UNITED STATES PATENT AND TRADEMARK OFFICE

APPLICATION NO.	FILING DATE	FIRST NAMED INVENTOR	ATTORNEY DOCKET NO.	CONFIRMATION NO.
10/771,522	02/05/2004	Junpei Ogawa	023971-0371	3059
22428	7590	09/22/2005	EXAMINER	
FOLEY AND LARDNER SUITE 500 3000 K STREET NW WASHINGTON, DC 20007			LUONG, VINH	
			ART UNIT	PAPER NUMBER
			3682

Office Action Summary

【図11】

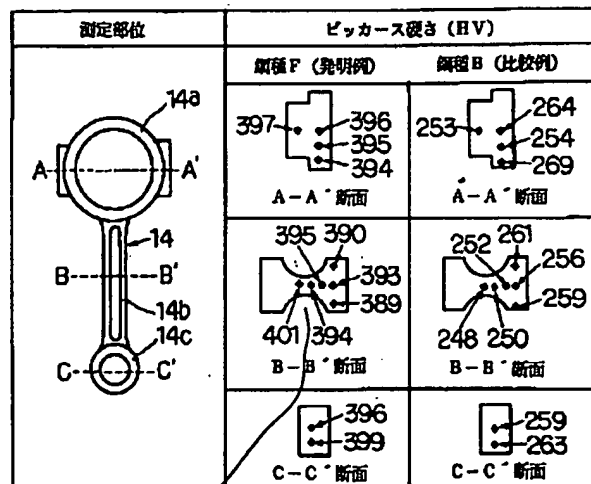
- a connecting beam section (at 14b in Fig. 11(D). See Attachment) serving as a main body of the connecting rod;

wherein each of the first and second joining sections (Att.) gradually and continuously decreases in cross sectional area toward the connecting beam section (Fig. 12) and has a strength distribution in which a strength increases with a decrease in the cross sectional area.

Claim 1 recites “wherein each of the first and second joining sections (Att.) gradually and continuously decreases in cross sectional area toward the connecting beam section (Fig. 12) and *has a strength distribution in which a strength increases with a decrease in the cross sectional area.*” (Emphasis added).
